**PLANNED UNIT DEVELOPMENT  
STAFF REPORT****Date: June 7, 2007**

**DEVELOPMENT NAME** Corrected Heron Lakes Subdivision, Phase 2, Lot 119

**CONTEMPLATED USE** Planned Unit Development Approval to amend a previously approved Planned Unit Development to allow increased site coverage and modify the rear setback.

# SITE PLAN

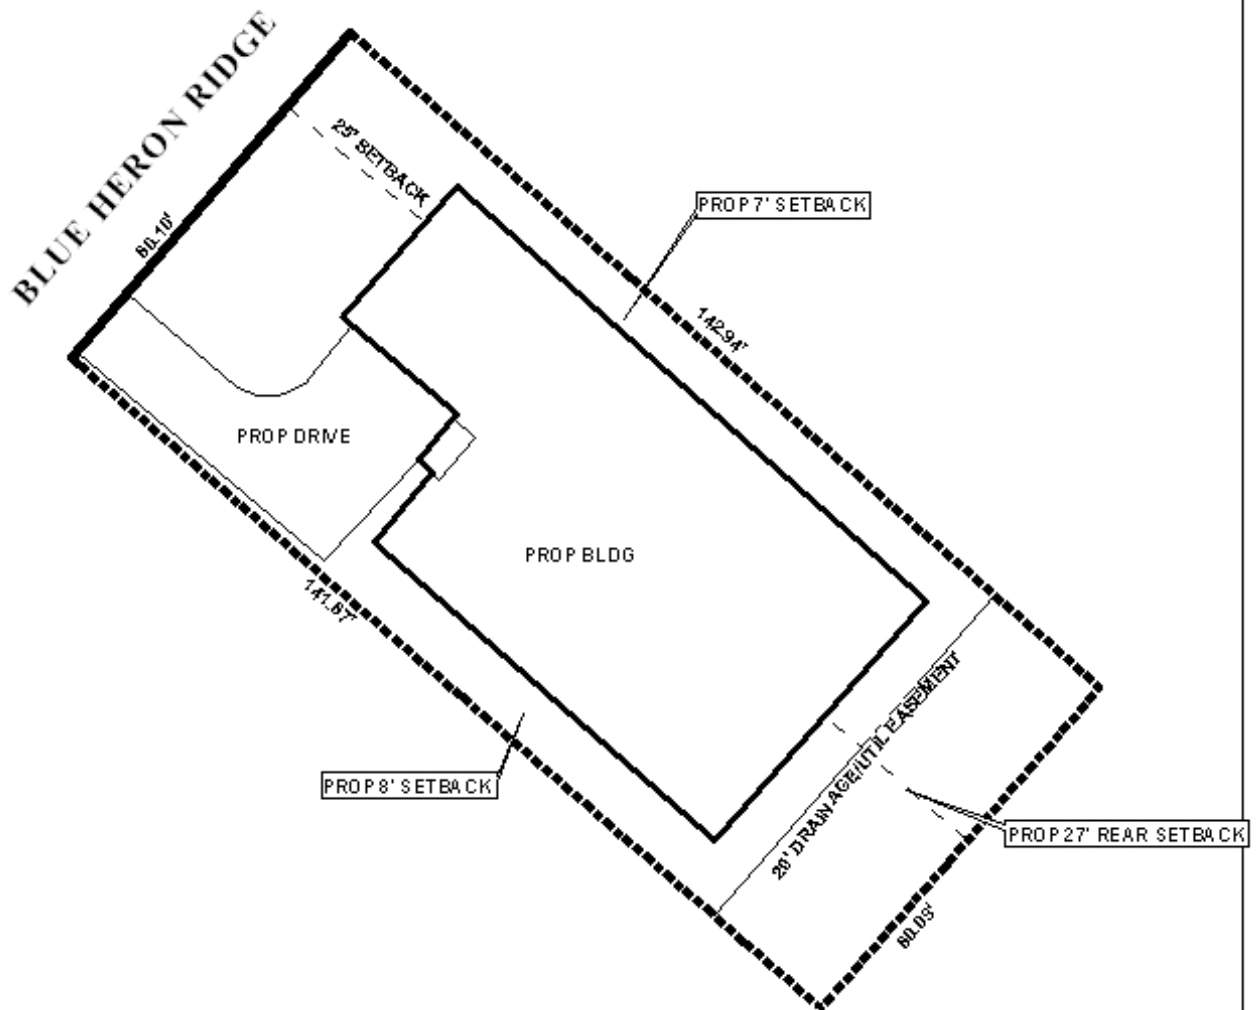
**COMMENTS** Verify that the pond can handle the additional proposed impervious area. It is the responsibility of the applicant to look up the site in the City of Mobile (COM) GIS system and verify if NWI wetlands are depicted on the site. If the COM GIS shows wetlands on the site, it is the responsibility of the applicant to confirm or deny the existence of wetlands on-site. If wetlands are present, they should be depicted on plans and/or plat, and no work/disturbance can be performed without a permit from the Corps of Engineers. Must comply with all storm water and flood control ordinances. Any work performed in the right of way will require a right of way permit.

The applicant wishes to amend the previously approved PUD which allowed for reduced side yard setbacks. The original PUD allowed for reduced side yard setbacks only and did not address increased site coverage. In this case, the applicant wishes to construct a dwelling with a 3,475 square-foot footprint on an 8,520 square-foot lot, this represents just under 41% site coverage. Therefore, the applicant is requesting the amendment to the PUD to allow for the reduced setbacks which are already recorded as well as the increased site coverage.

Given the number of such requests and approvals, documentation should again be provided that the existing storm water system is adequate.

Based on the preceding, the application is recommended for Approval, subject to the following conditions: 1) submission of documentation that the existing storm water facilities are adequate to handle the increased site coverage (including all previously approved increases), to be approved by City Engineering Department prior to signing of the final plat.
